RE: Phased Subdivision Application for 6719 Devon Avenue SE (AMANDA 20-118048-LD)

PW Completeness Review_Civil Plans_Devon Estates.pdf Markup Summary

P410

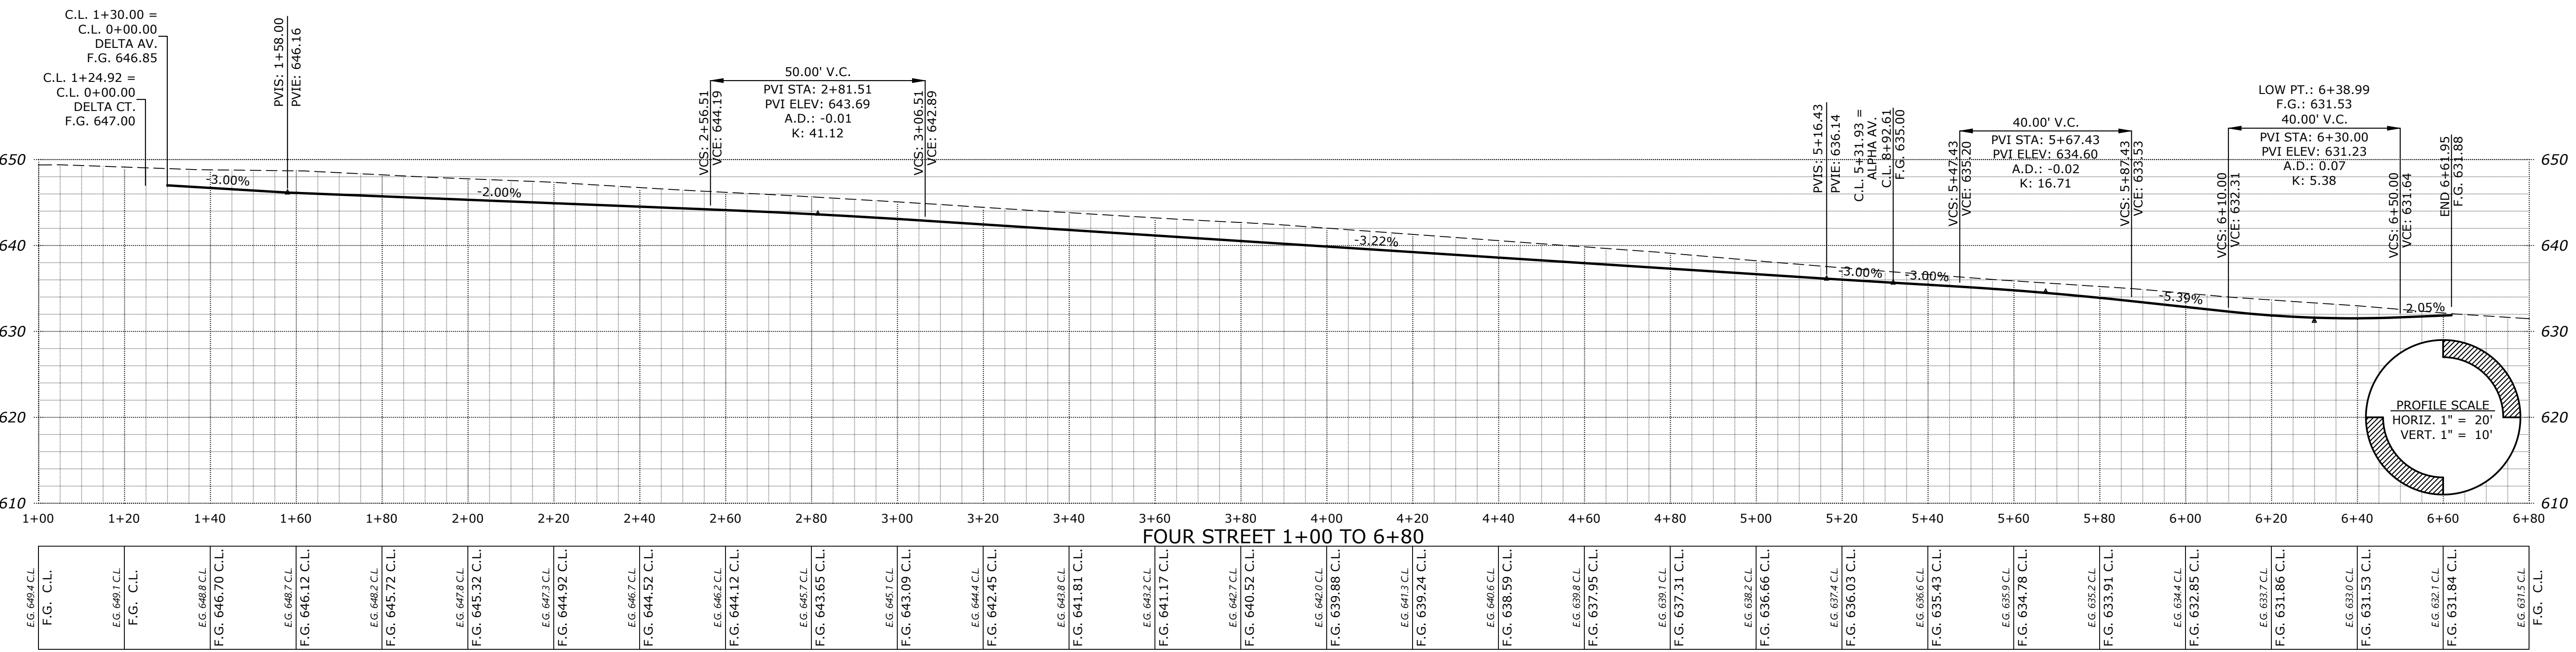
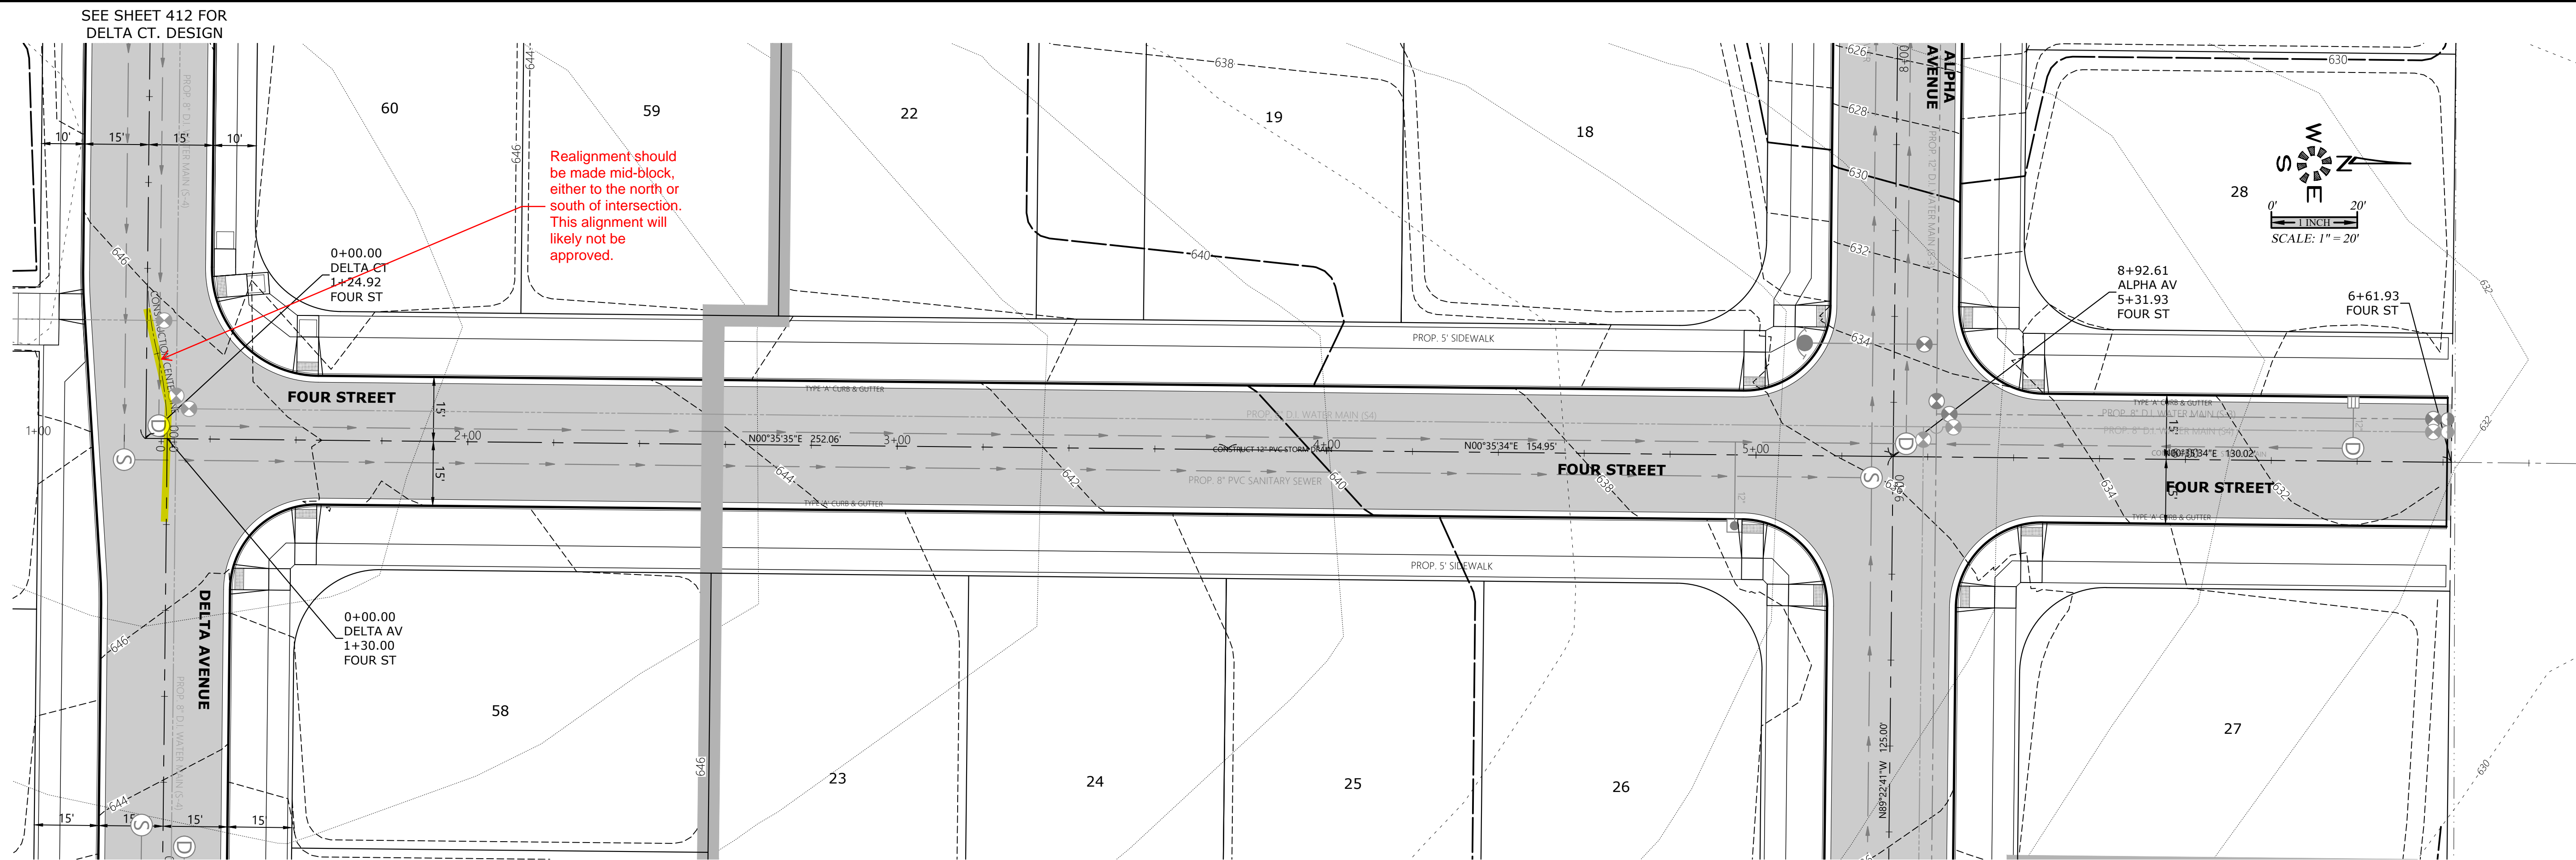
Realignment should be made mid-block, either to the north or south of intersection. This alignment will likely not be approved.
